RESPONSE TO REQUEST FOR ADDITIONAL INFORMATION

APR1400 Design Certification

Docket No. 52-046

RAI No.: 45-7883
SRP Section: 07.09 - Data Communication Systems
Application Section: Section 7.9
Date of RAI Issue: 06/23/2015

Figure 7.9-5-1 Data Communication Block Diagram

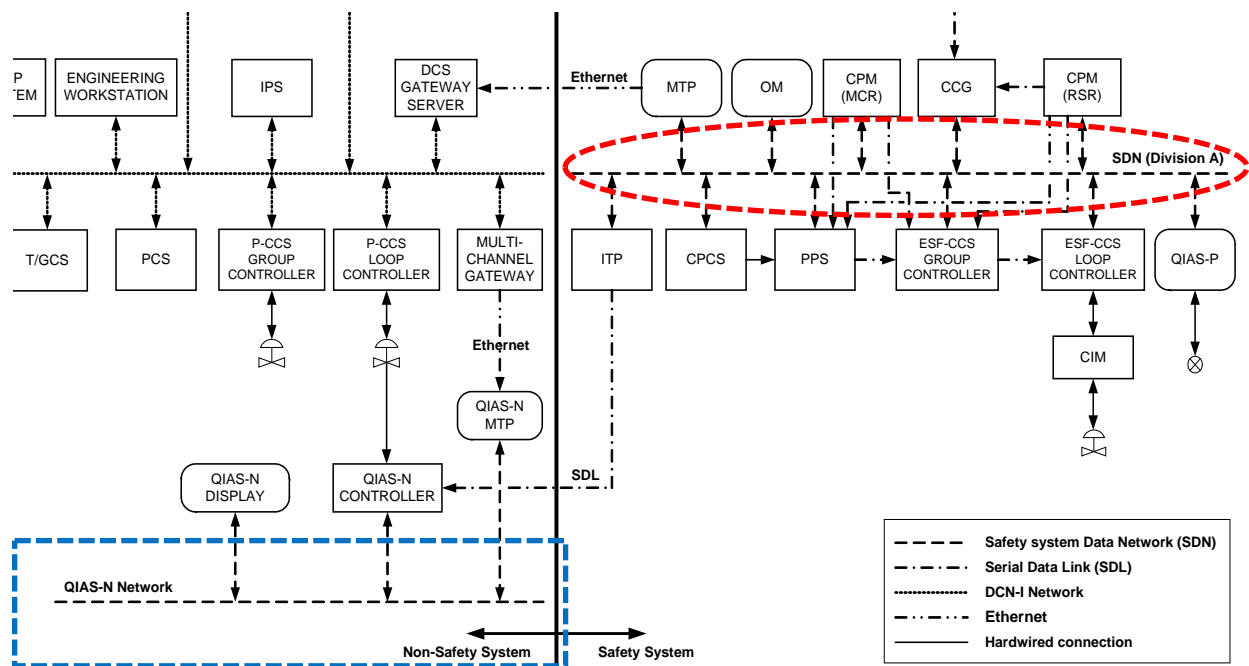
Clarify what is meant by "the Qualified Indication and Alarm System - non-safety (QIAS-N) network is implemented by the Safety System Data Network (SDN)."

APR1400 FSAR, Tier 2, Section 7.9.1.4, "Data Communication from Safety System to Non-Safety System" states, in part, "The QIAS-N network is implemented by the SDN." It is not clear what is meant by "is implemented by the SDN." Is the applicant trying to say QIAS-N network will be implemented using AF100 network communication system, which is discussed in the Common Q topical report? The staff requests applicant to clarify and update the FSAR accordingly.

The network marked with a red ellipse in the above figure is a dedicated network for the divisionalized safety systems such as plant protection system (PPS), core protection calculator system (CPCS), and engineered safety features-component control system (ESF-CCS). The network marked with a blue square is a dedicated network for the QIAS-N.

The two networks marked with a red ellipse and a blue square are different and designed in such a way that safety systems do not receive any signals from non-safety systems. These networks are also physically separated and electrically isolated. However, these networks are implemented with the SDN. The SDN means the AF100 communication network discussed in the Common Q topical report.

Therefore, "The QIAS-N network is implemented by the SDN." means that the QIAS-N network is implemented with the AF100 communication network.
